CLOVER SHOPPING
CENTER REDEVELOPMENT

PREPARED FOR
KRAUS
ANDERSON

BLOOMINGTON MINNESOTA

CLOVER SHOPPING
CENTER EXHIBIT

EX 1

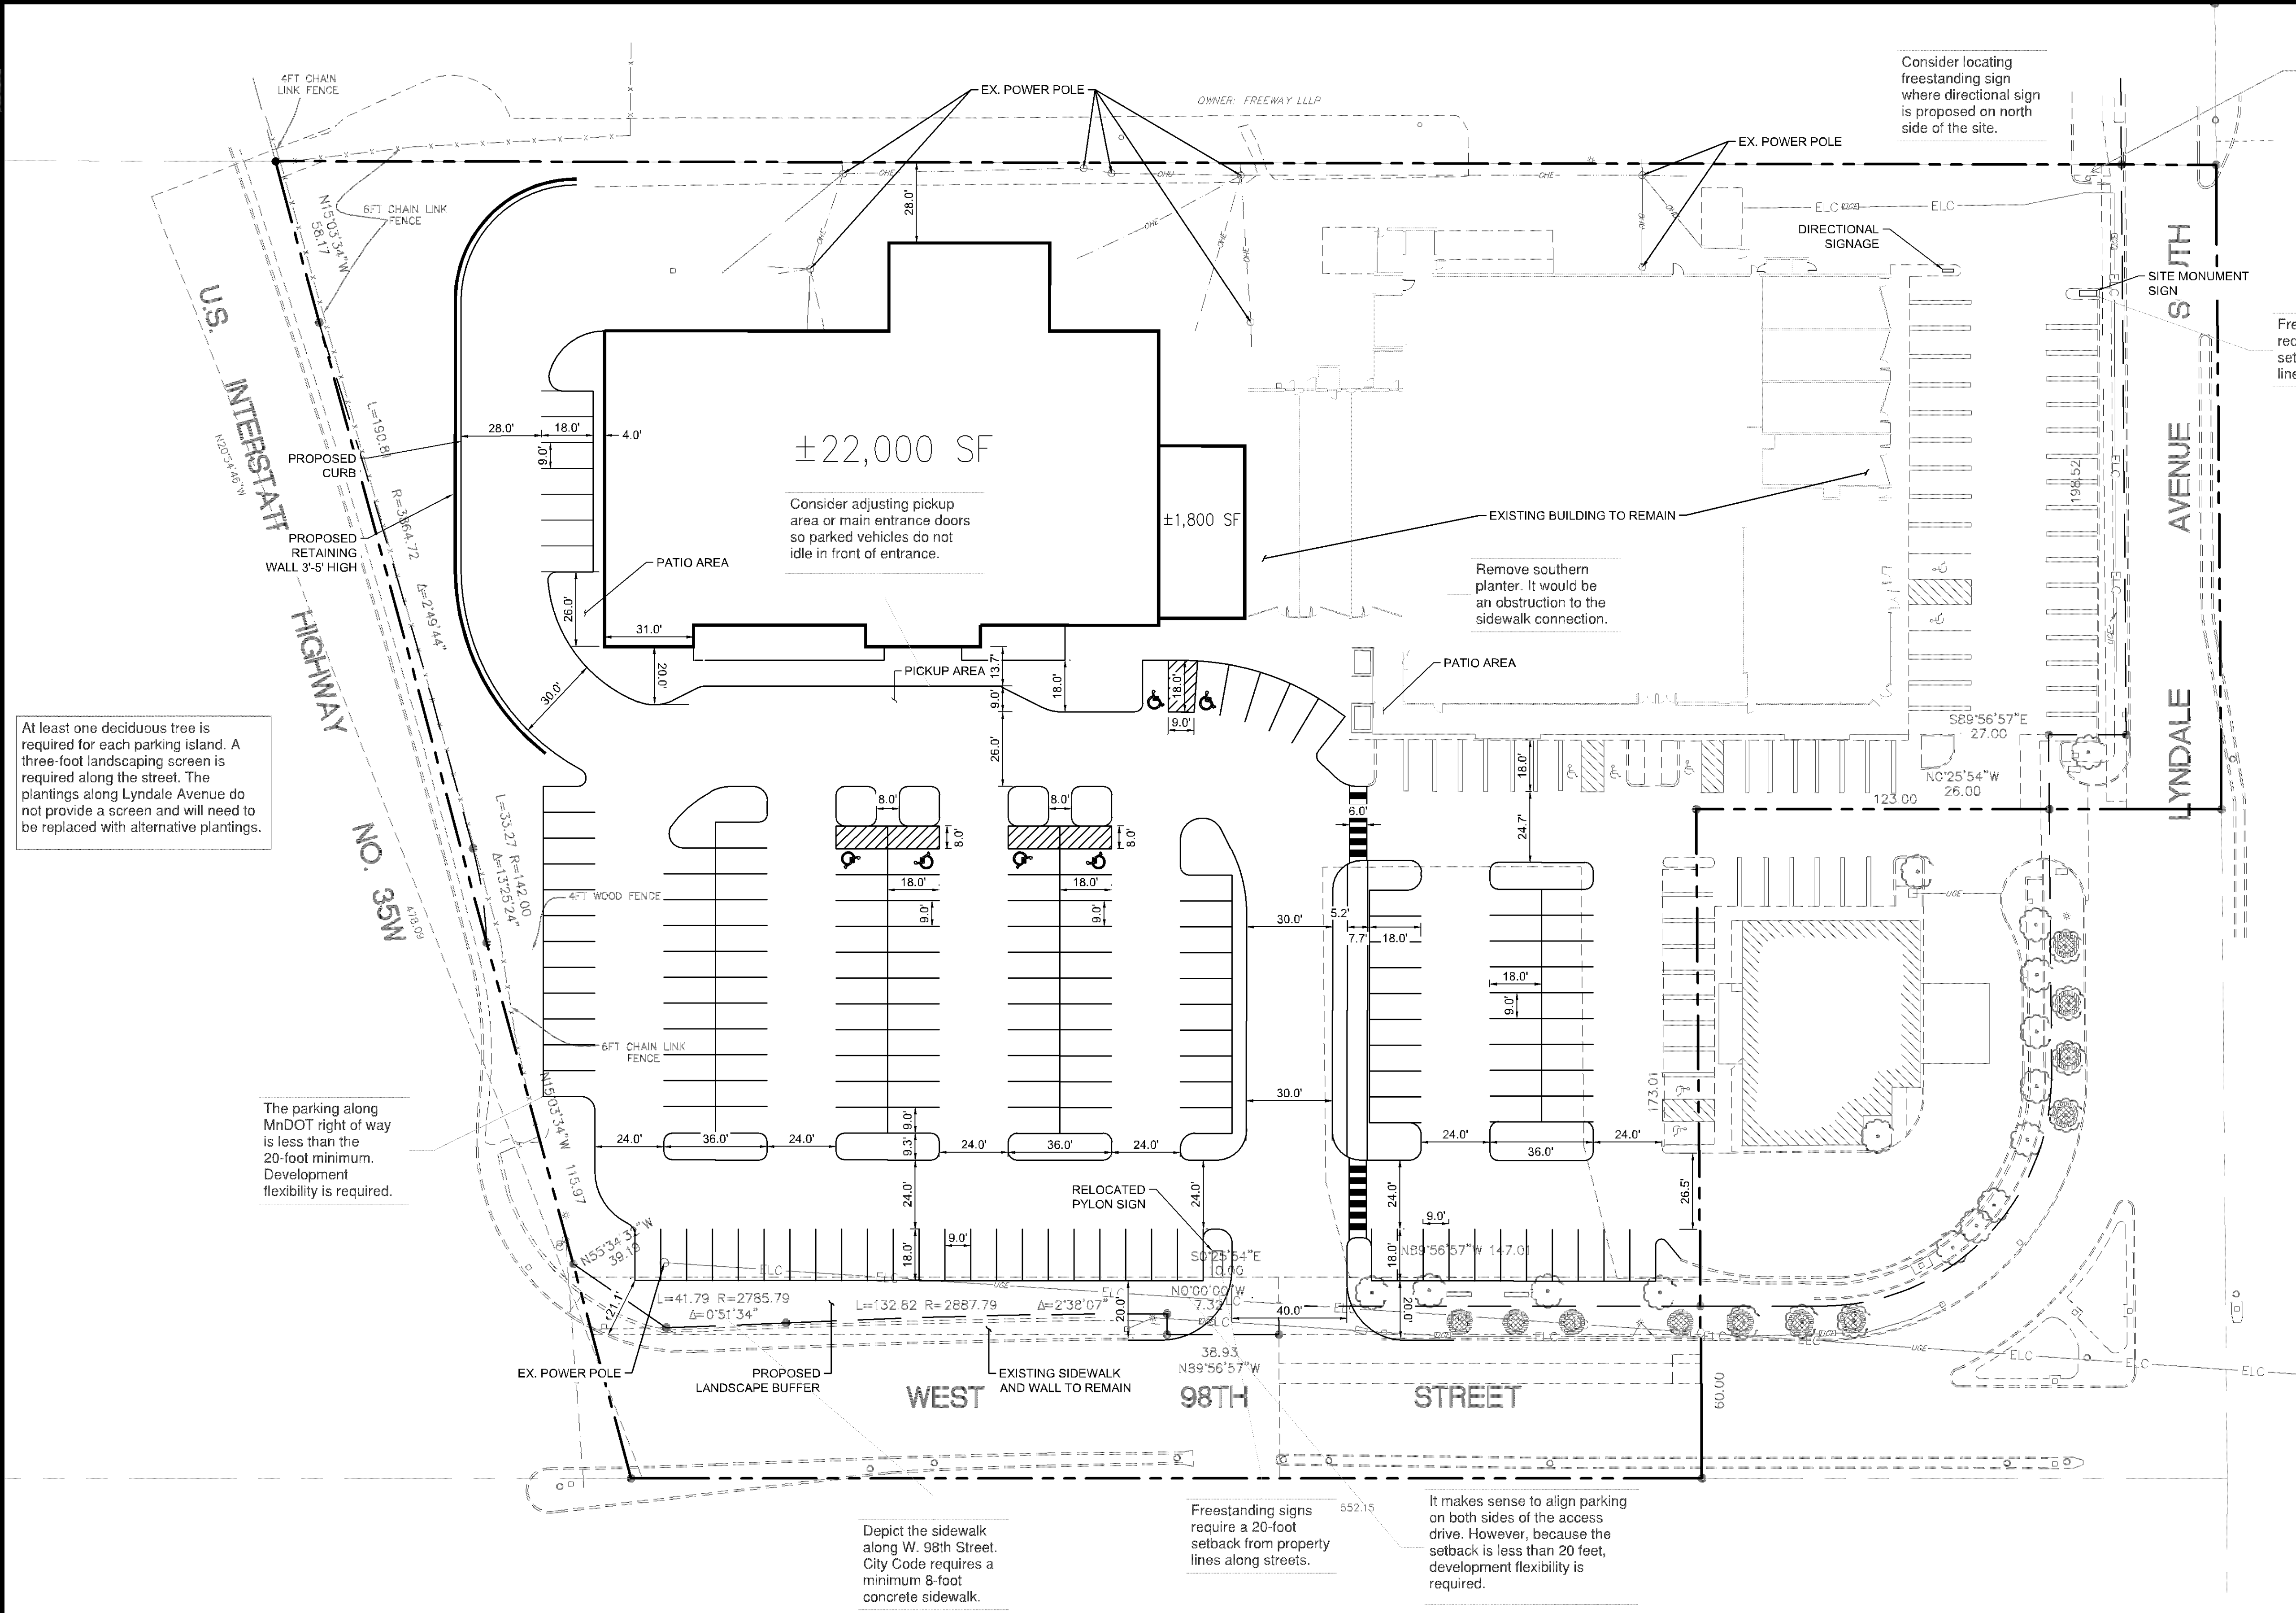
Must meet 2020 MN State Building Code

Must meet 2020 MN Accessibility Code.

Provide a detailed code analysis with the plans.

SAC review by MET council will be required.

Building plans must be signed by a MN licensed architect.

Existing Clover Center Sign must be relocated/removed.

Freestanding signs require a 20-foot setback from property lines along streets.

The overall parking requirement with the proposed redevelopment would decrease. Please provide the uses for tenant spaces, including the number of seats for restaurants. Staff will prepare a parking analysis to determine the level of deviation from City Code. Depending on the level of deviation, a parking study may be necessary prior to the City accepting a development application

A traffic study will be necessary prior to the City accepting a development application

EX 2

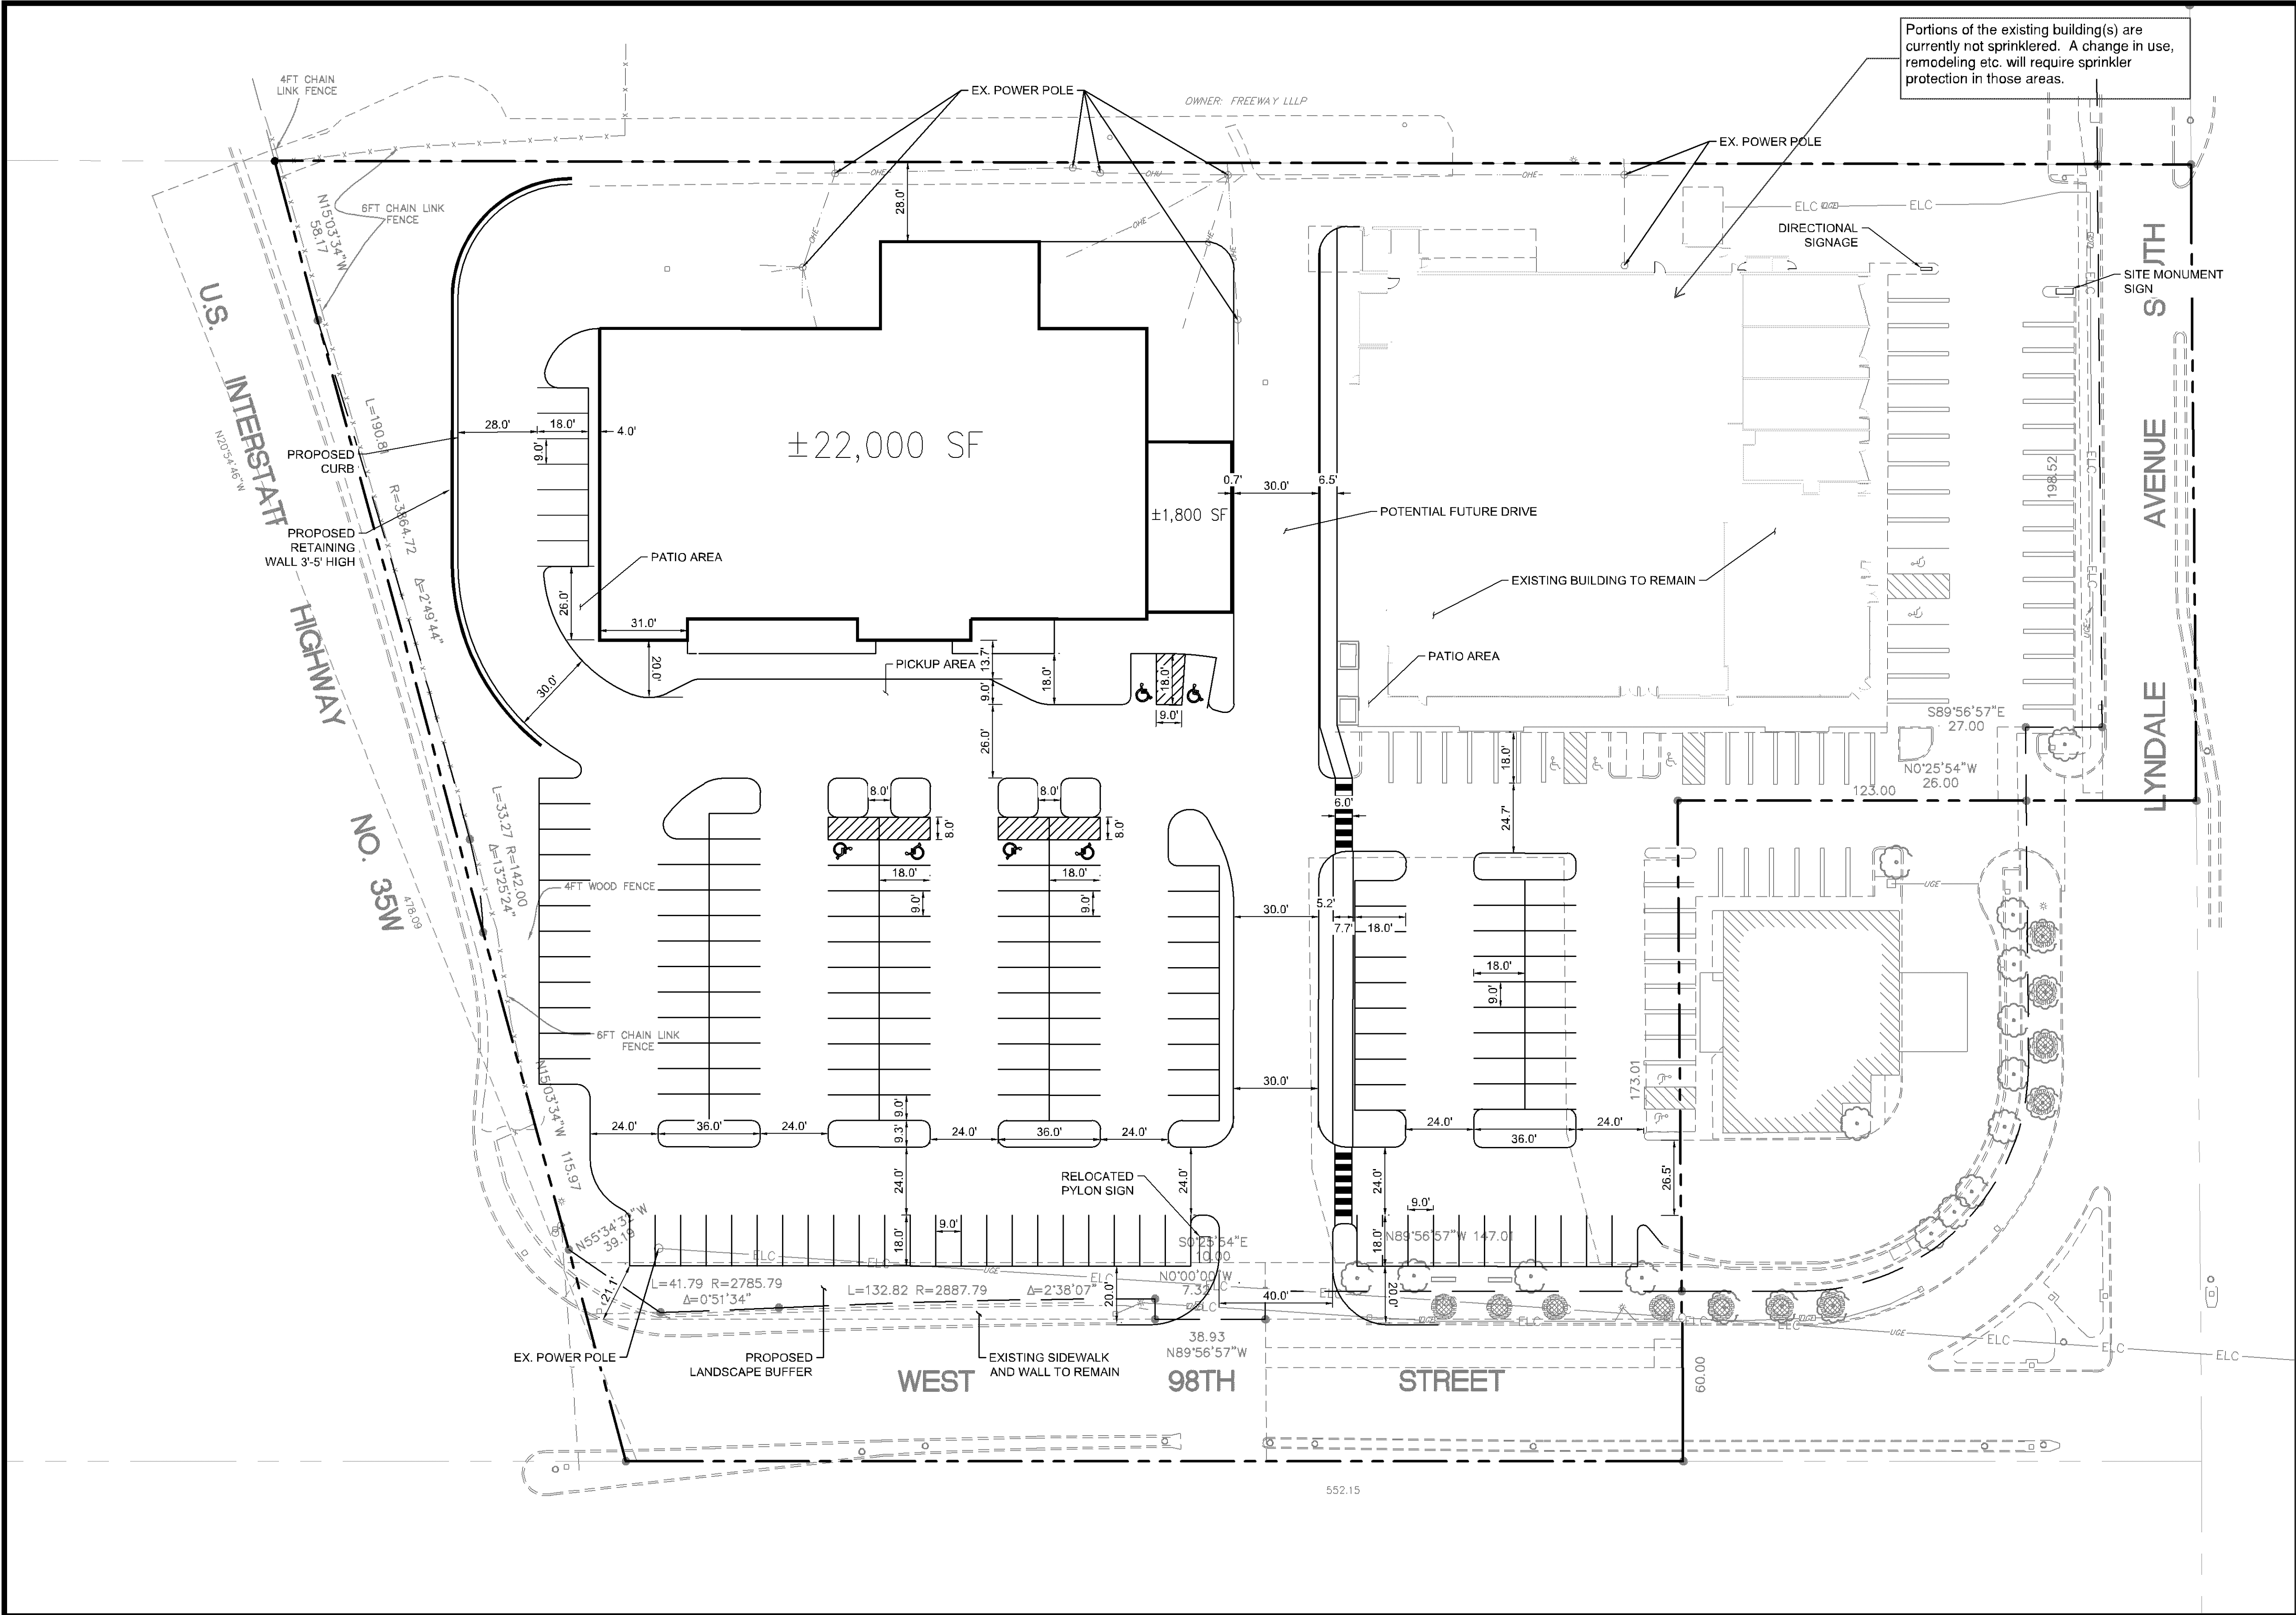
Provide adequate turning radius for BFD Ladder 3.

Additional hydrants will be required to provide coverage within 150' of all exterior walls.

"EX 2" could be identified as a Phase II for the Clover Center preliminary development plan. Also envision what a Phase III and any additional phases would entail.

The City has very specific standards pertaining to exterior building materials. Brick, glass, and stucco are permitted primary building materials. There are limitations on "secondary" materials such as EIFS and fiber cement panels. Metal panels may be permitted as "primary" material, subject to finish warranty and gauge requirements.
